Comment Supporting materials: The Reuse of 10GbE SRS Test for SR4/10, 40G-LR4

Frank Chang
Vitesse

Consider SR4/10 SRS in Table 86-10 (#331)

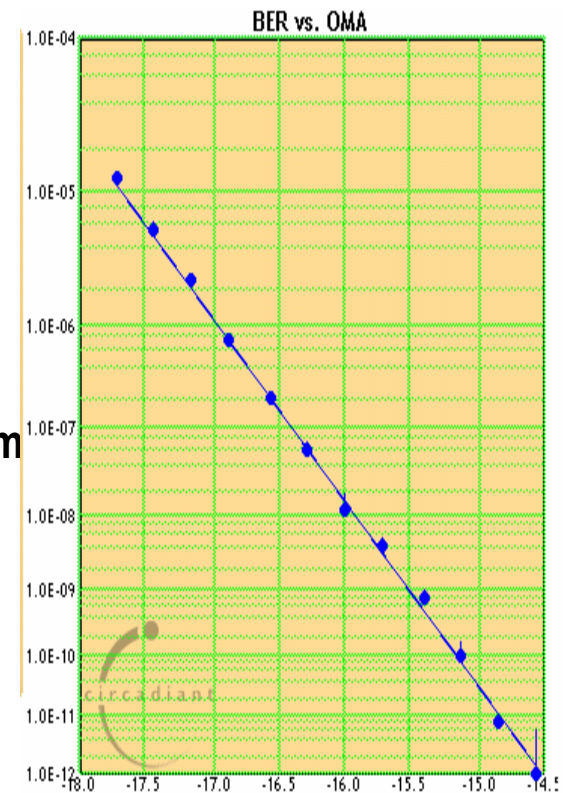
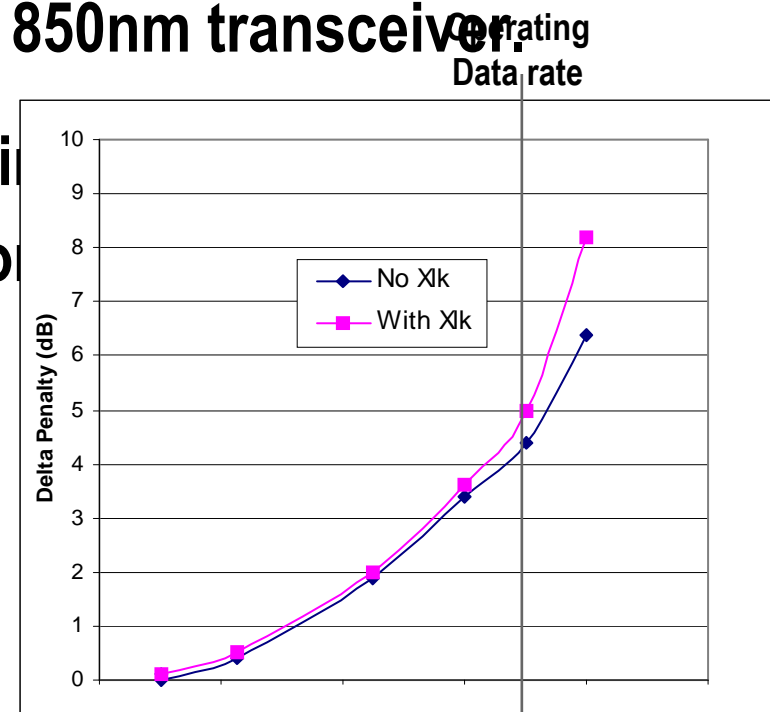
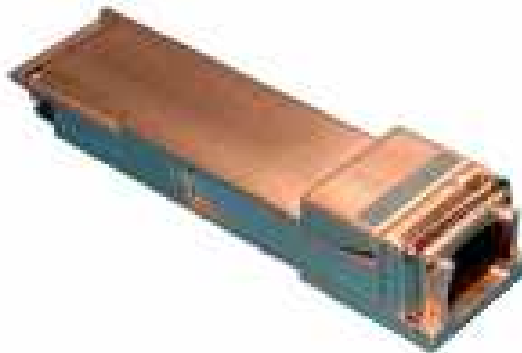
- ▶ SRS values are for system level BER measurements which include the effects of CDR circuits.
- ▶ **Measured SRS in OMA for Off-the-shelf parts .**
 - ▶ 10GBASE-SR:
 - Normally show better than -11dBm in OMA against -7.5dBm
 - Typically >3.5dB margin.
 - ▶ 10GBASE-LR:
 - Normally show better than -13dBm in OMA against -10.3dBm
 - Typically >2.5dB margin (slightly less)
 - ▶ 10GBASE-ER:
 - Normally show SRS < -14.5dBm in OMA against -11.3dBm
 - RX sens. for Clean eye is about -17dBm against -14.1dBm.
 - Typically over 3dB margin

- ▶ The Xtalk for SR4/10 and 40G-LR4 are budgeted by reduced RX sens.
- ▶ Multi-channel Xtalk mainly come from adjacent channels, estimated from prototyped QSFP 850nm transceiver.
- ▶ Measured Xtalk is ~1dB at operating Data rate (Sound reasonable to defined worst case Xtalk at ~2dB.)

Xtalk is estimated with all other channels having ~300mVpp (diff) sync and async data input.

Table 86–17—Applied sinusoidal jitter

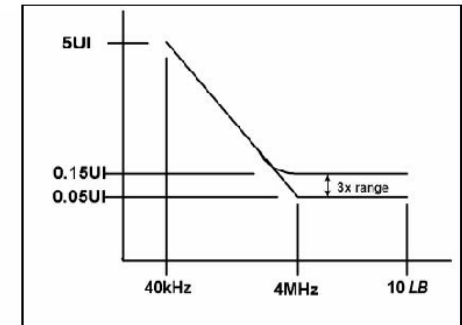
- ▶ RX jitter tolerance is tested against sinusoidal jitter mask.
- ▶ Adopt 10GbE-R SRS test specs as well-established test methodology with commercial testset available.

$2 \times 10^5 / f + S - 0.05$

$0.05 \leq S \leq 0.15$

Note: S is the sine jitter value used actually for calibration of the stressed eye.
